Meeting Agenda
Wilsonville Parks & Recreation Advisory Board
May 23, 2013 6:30 p.m.
Wilsonville City Hall-Council Chambers

PLANNING DIVISION MEMORANDUM

TO: Parks and Recreation Advisory Board
DATE: May 20, 2013
FROM: Daniel Pauly AICP, Associate Planner
RE: Review of Villebois Regional Park 4 and Open Space 2
Planning Case File No. DB13-0026

L4.0

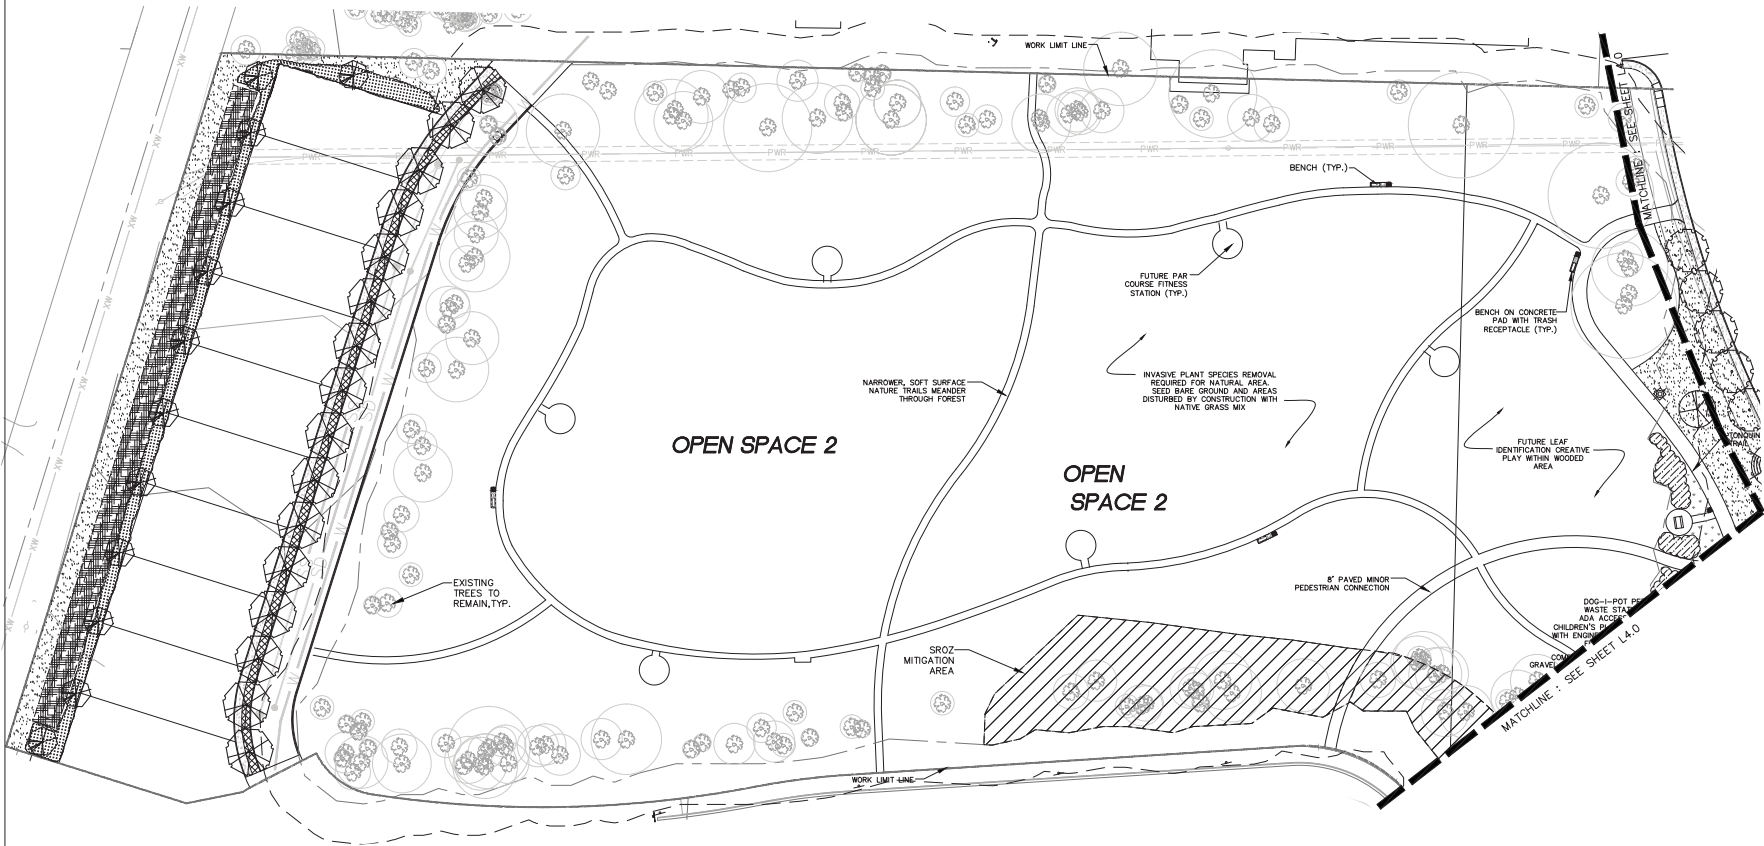
The park includes all of the features called for in the parks portion of the Villebois Village Master Plan except a horseshoe pit. Staff supports this feature being omitted as it was added in Picadilly Park (Regional Park 3) immediately to the south. The following is a list of amenities called for in the Villebois Village Master Plan and how the park design incorporates them.

General Lawn Play: A large, level general lawn play area is proposed at the southern end of the park. It is smaller than described in the Villebois Village Master Plan, but appropriate when looking at other park programming needs and design considerations, including preservation of trees and natural areas.

Staff finds that the applicant's proposed design supportive of the parks component of the Villebois Village Master Plan and appropriate for the site.

Figure 7

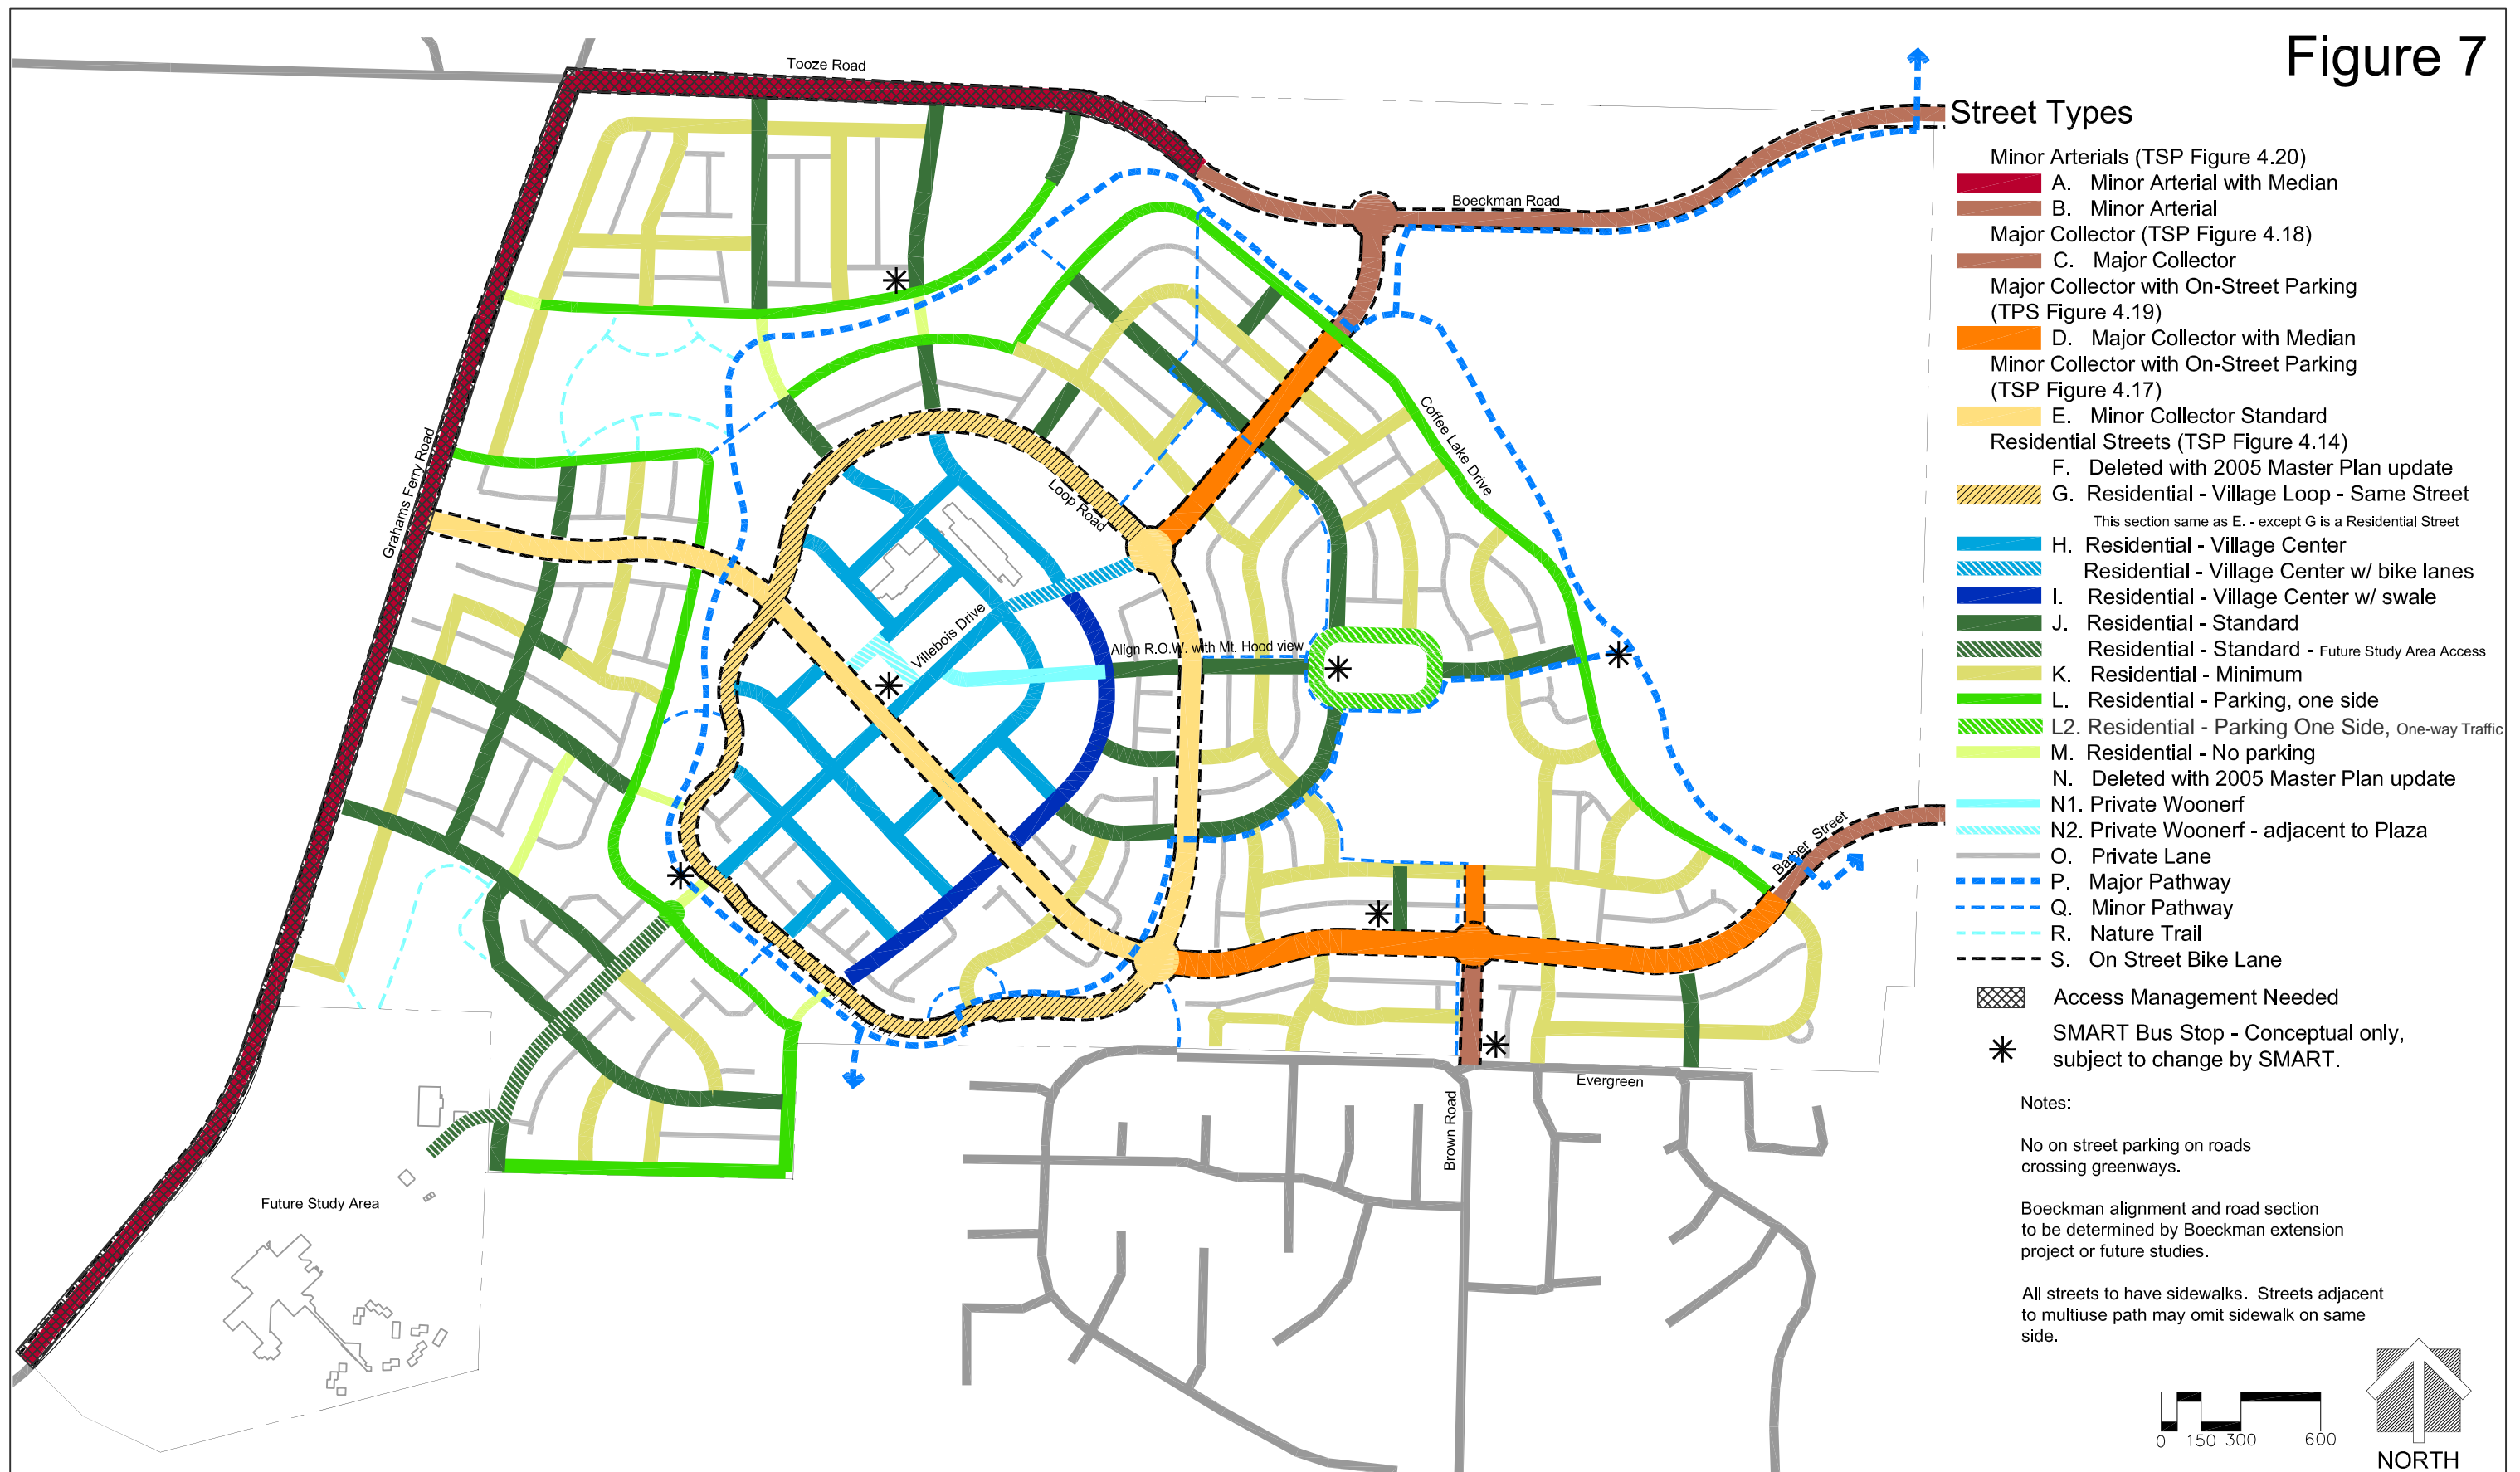
Ice Age Tonquin Trail: Coming across Barber Street at Costa Circle from Regional Park 3 the shared-use path turns to the west toward a beautiful wooded area. It continues along the edge of the wooded area on the west side of the park providing a through path as well as access to the various park amenities. The trail extends to Ravenna Loop on the northern edge where it will cross mid-block into Regional Park 5. See Exhibit I.

Mid-block Bicycle and Pedestrian Connection: The Villebois Village Master plan shows a mid-block bicycle and pedestrian crossing through the park and adjacent Open Space 2. The path is proposed arching from the Ravenna Loop/Geneva Loop intersection through the forested area to Palermo Street on the west side of the park. See Exhibit I.
